ADDENDUM

Project Name: 2010 improvements
A New Fire Station
For Culberson County
Van Horn Texas

Addendum No.: **Seven (7)**
Date: 15 February 2010
Project No.: 09128

SD-5

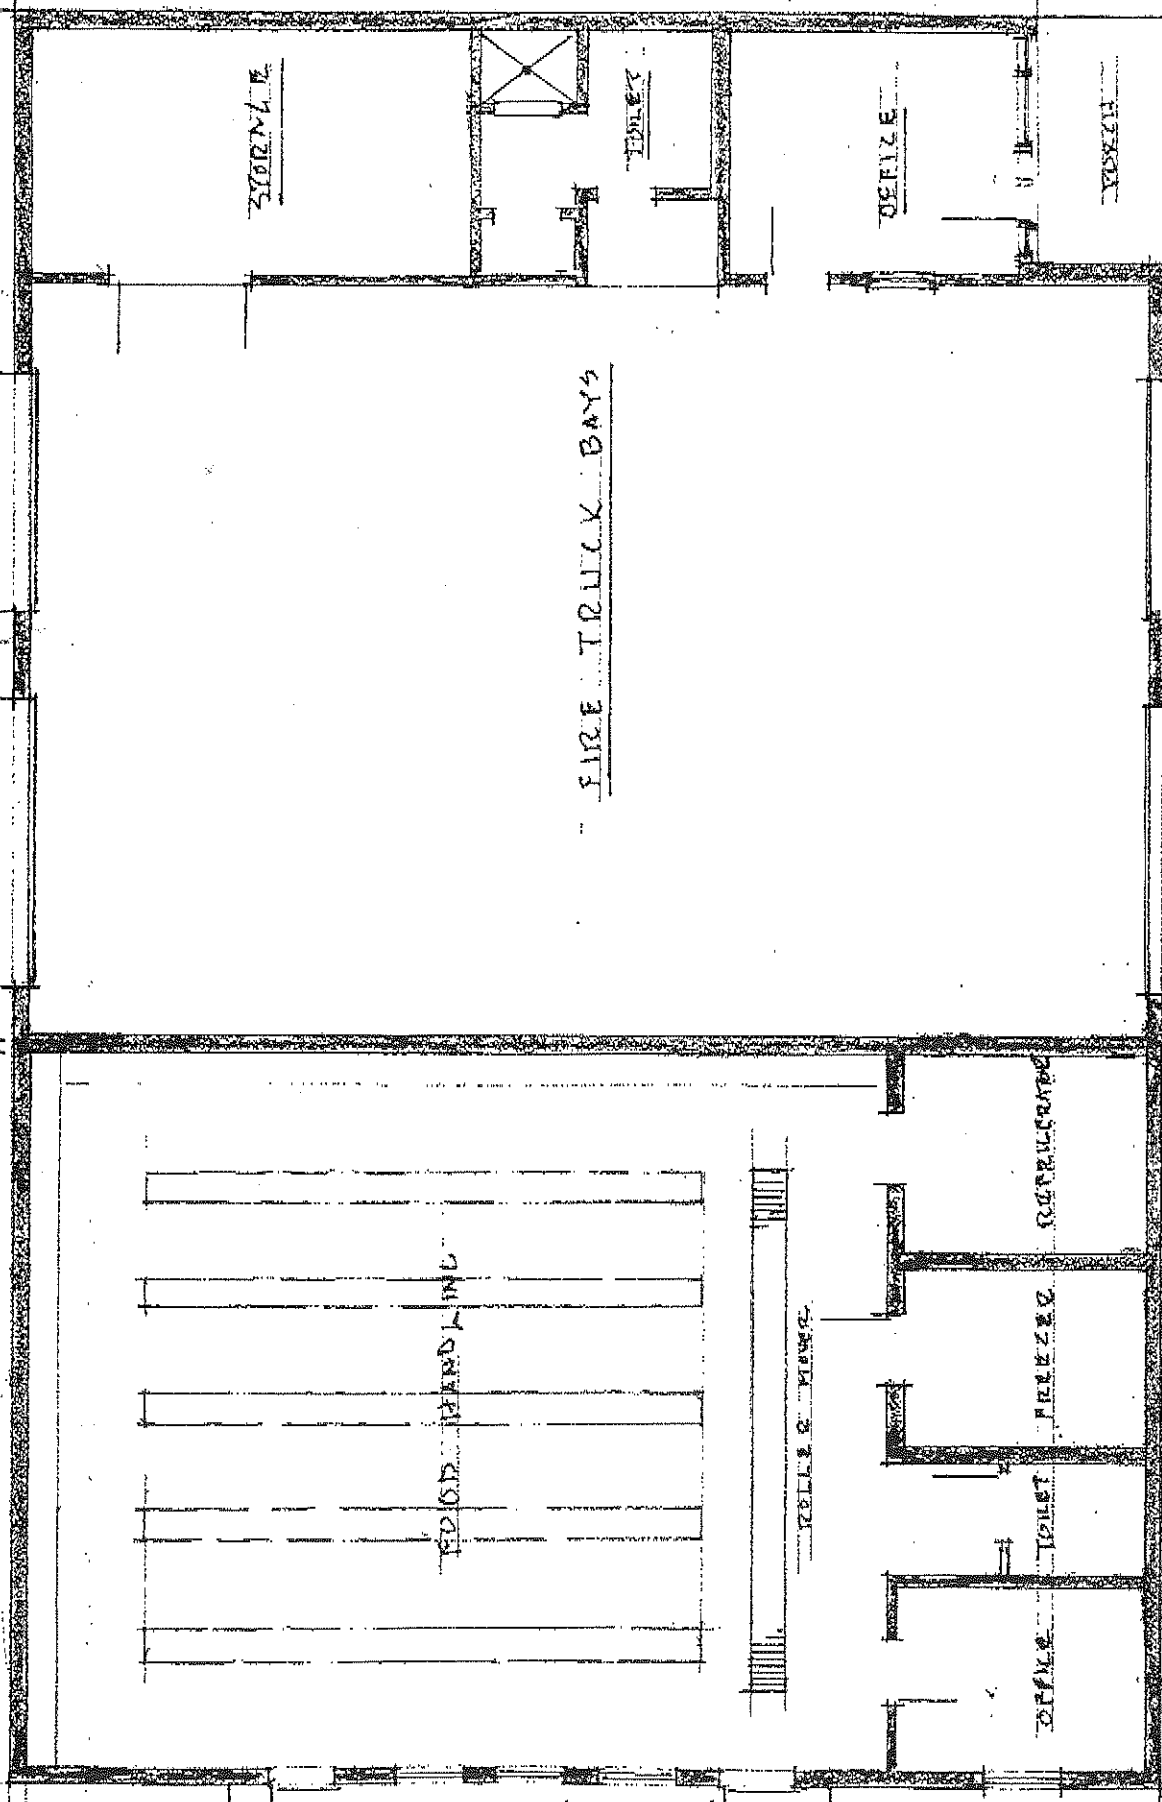
Item No. Two: Alternate #9: Combine the food bank and the fire station into one building. See attached supplemental drawings SD5, SD-6 and SD-7. Notice that the roof structure of the food bank will be supported on the east-side by the rigid frames and/or the steel columns of the fire station. Provide 4' x4' x2' piers under west wall rigid frames for food bank.
